**TOWN OF BAY HARBOR ISLANDS
DEVELOPMENT & REVIEW COMMITTEE MEETING
THURSDAY, FEBRUARY 9, 2023**

1. Review and discussion of Site Plan Application by DDG 100 Street BHI, LLC, to construct an 18-unit Multi-Family Development to be located at 1130 - 1140 100 Street. Enclosed are the Site Plans and the Staff Report prepared by Town Planner Michael Miller.
2. Review and discussion of Site Plan Application by LDC WBHD Property Owner, LLC, to construct a 9-unit Multi-Family Development to be located at 9110 West Bay Harbor Drive. Enclosed are the Site Plans and the Staff Report prepared by Town Planner Michael Miller.
3. Review and discussion of Site Plan Application by 1177 Bay Harbor Islands, LLC, for a revision to the previously approved New Commercial Mixed Used Building to be located at 1177 Kane Concourse. Enclosed are the Site Plans and the Staff Report prepared by Town Planner Michael Miller.

Subject: Site Development Plan Application (#2 Review)
1130 - 1140 100th Street – New Multi-family Residential Complex (18 DU)
Bay Harbor Islands Acct. No.: SPR23-000001
MMPA Acct. No. 01-0702-1151

TITLE
BUILDING ELEVATION
SOUTH & NORTH

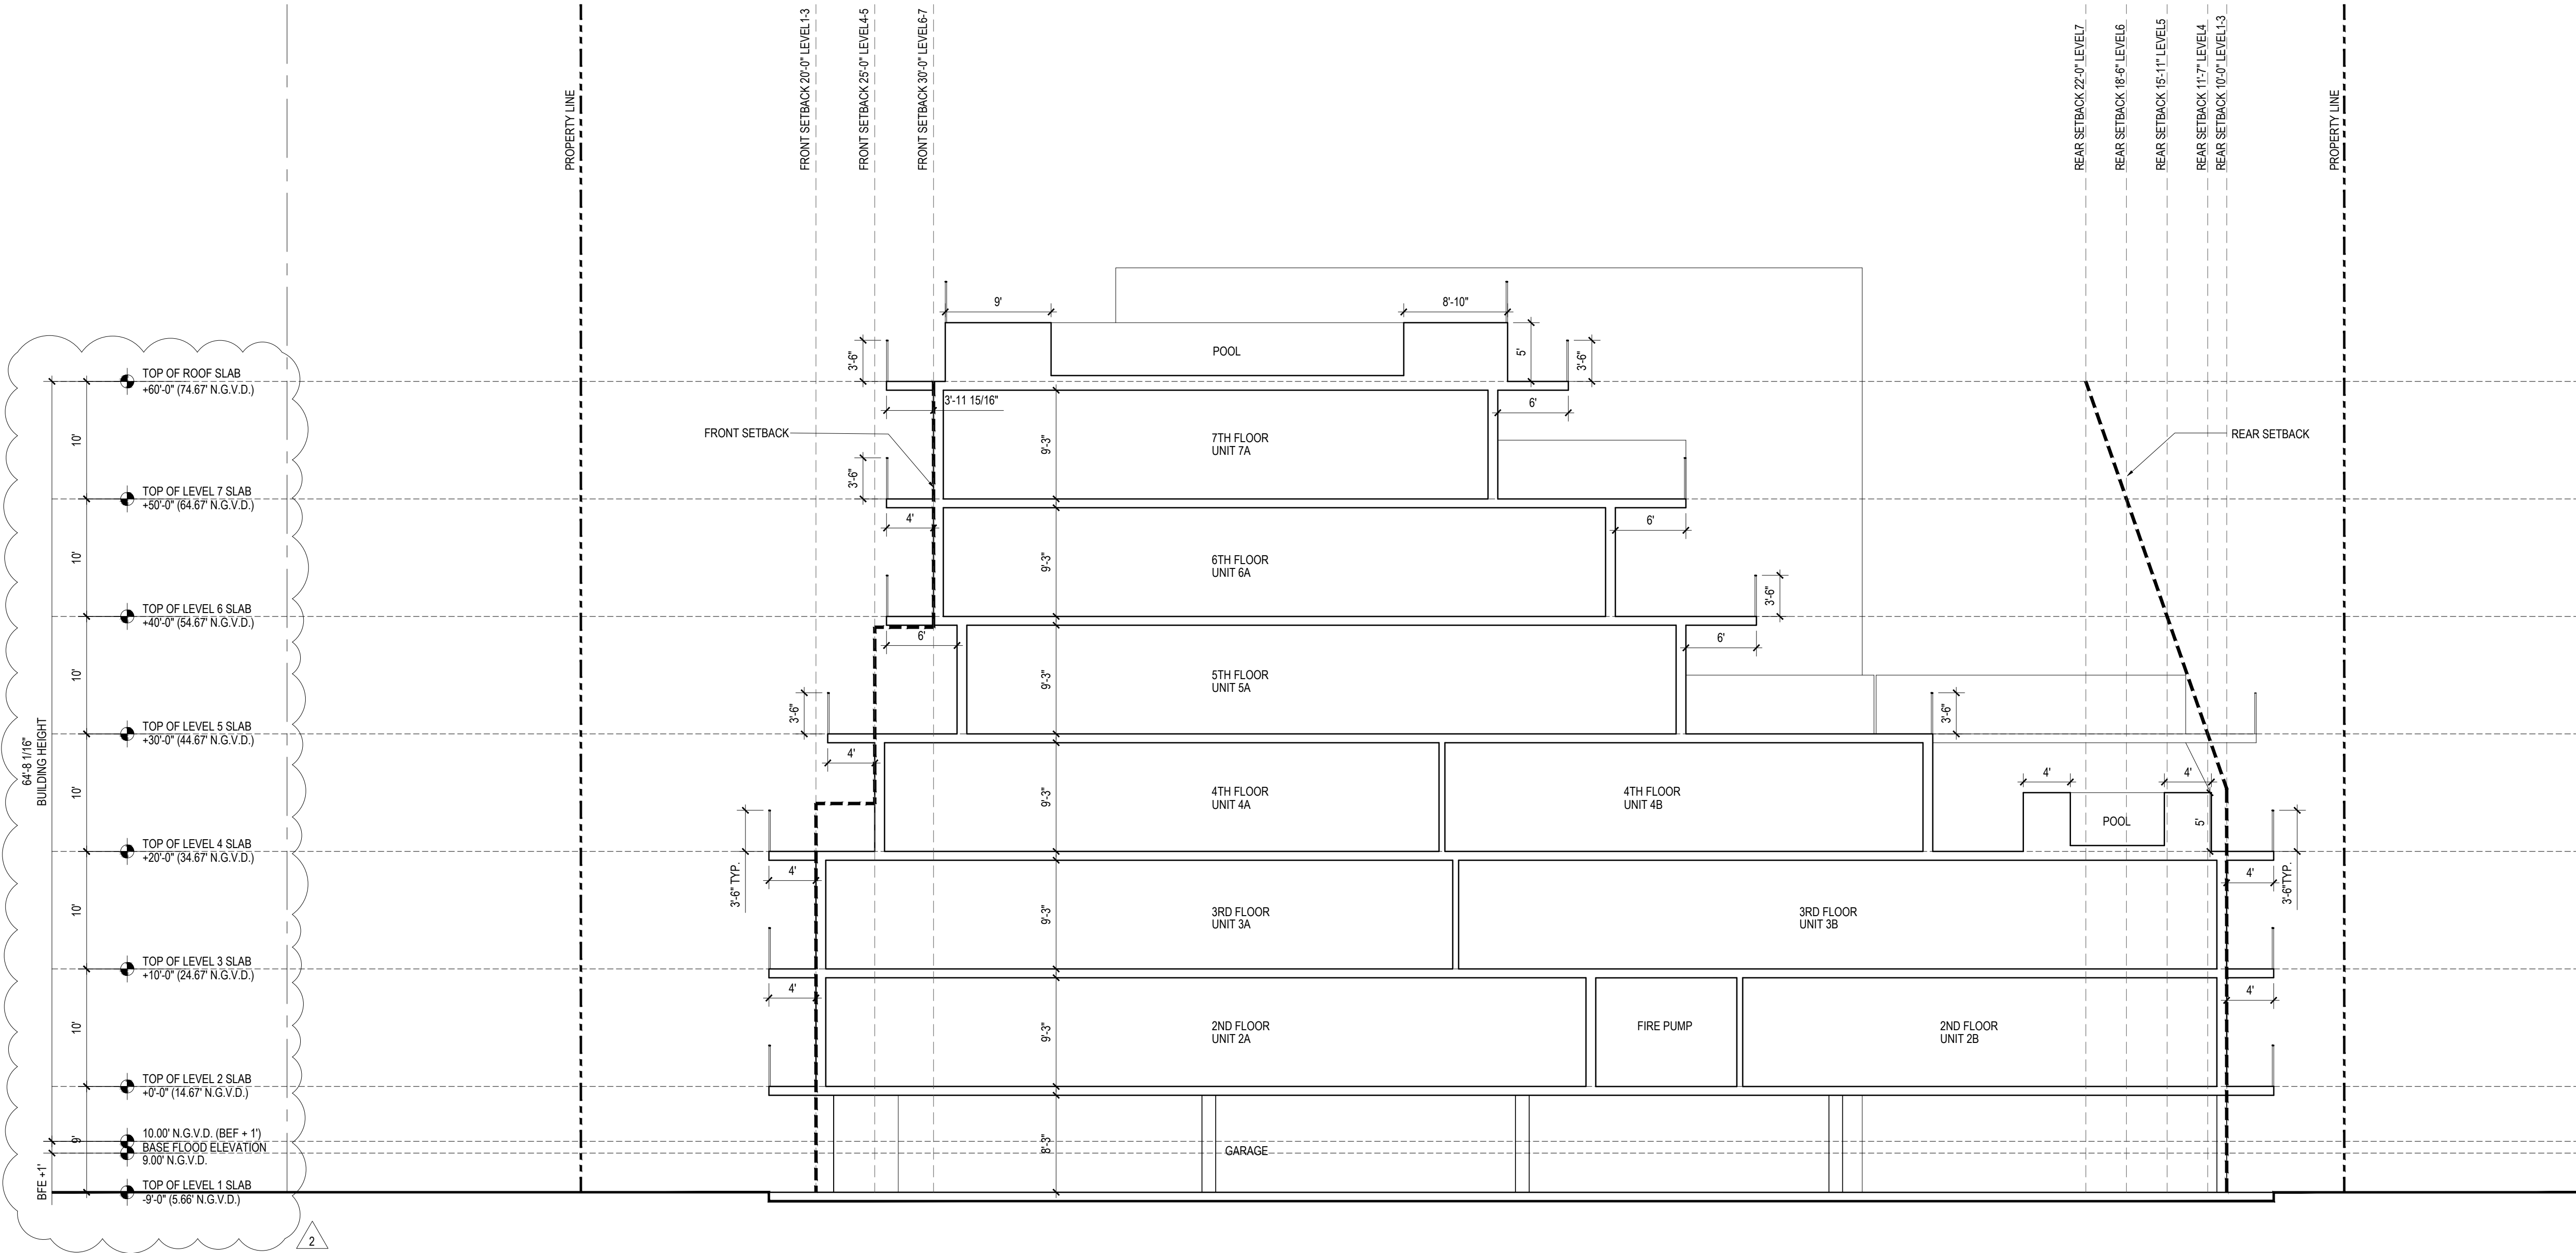
8) The building height measurements appear to incorrect oni the building elevations sheets - need clarity. Allowable building height is measured from the current FEMA BFE + 1' of FBC freeboard. The current FEMA flood map depicts two flood zones on this site (split N/S in middle of the site) as AE-8.0' and AE-9.0' NGVD- so the more stringent applies. Therefore, the lowest habitable floor must be 9.00' NGVD + 1' FBC freeboard or 10.0' NGVD. The plans show a BFE elevation of 10.67' NGVD. FEMA should be adopting a new Flood Map for Miami-Dade County shortly (draft been reviewed for some time). The new draft FEMA map will show 7.0' NAVO for the entire Town (now 3 different flood zones). When the new FEMA map is adopted and becomes effective the elevation will be 7.0' NAVO + 1' FBC Freeboard = 8.0' NAVO. Using the math conversion for NAVO/ NGVD of 1.67' the future required BFE flood elevation/ elevation at which building height is measured will be 9.67' NGVD. The plans show building height measured from 10.67' NGVD. Revise the plans.	Plans have been revised accordingly and dimensions have been provided. Building height is measured from 10.0' NGVD, which is BFE 9.0' plus 1' freeboard, and is 64'-8 1/16". Please see sheets A-21, A-22, A-23, A-24 and A-41.

Date	01-26-2023	Sheet No.
Scale		A2.00
Project	2234

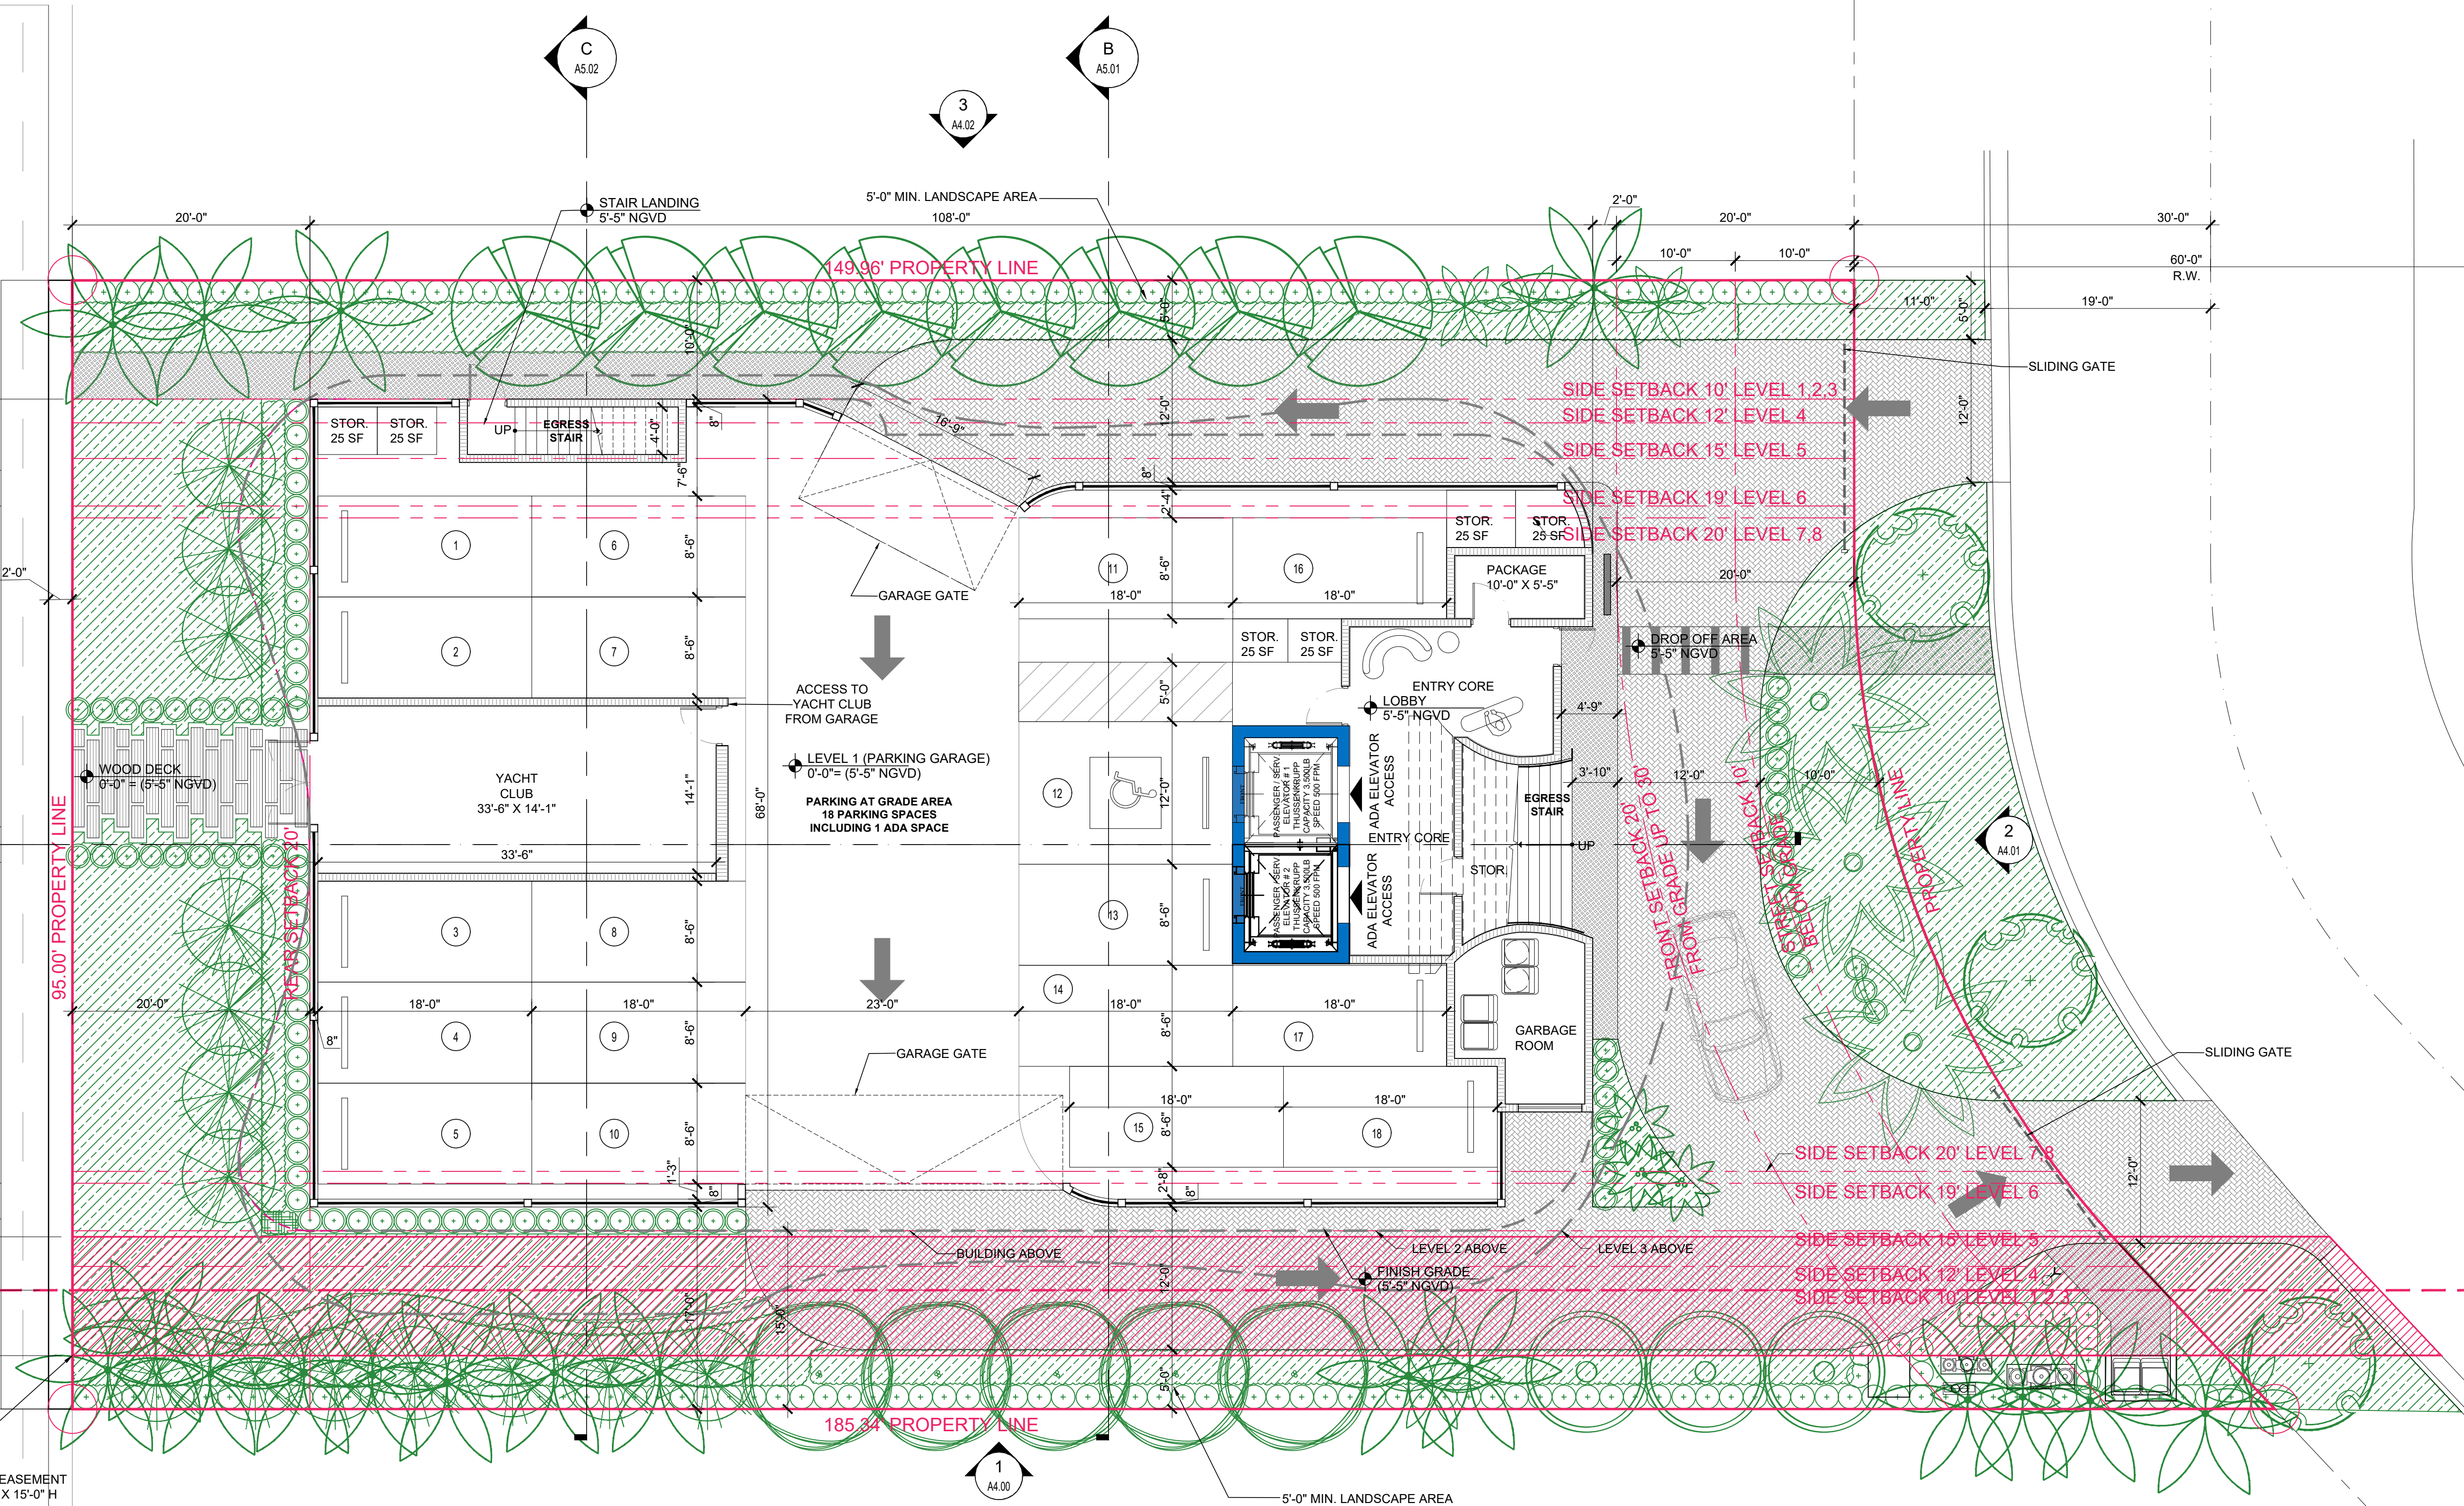
- 5) On Sheet A1.00 in the Site Data Table the Flex Setback calculations are incorrect (shows 10' reqd. & provided but that is not true and the design is much more – but appears to meet Code). The allowable Flex setbacks can be 33.3% of the allowable building width or length. For example, for the front / rear the allowable Flex setback width is 24.97'. For the north façade it is 36.62'. For the south façade it is 48.39'. Please correct the table to include correct information.
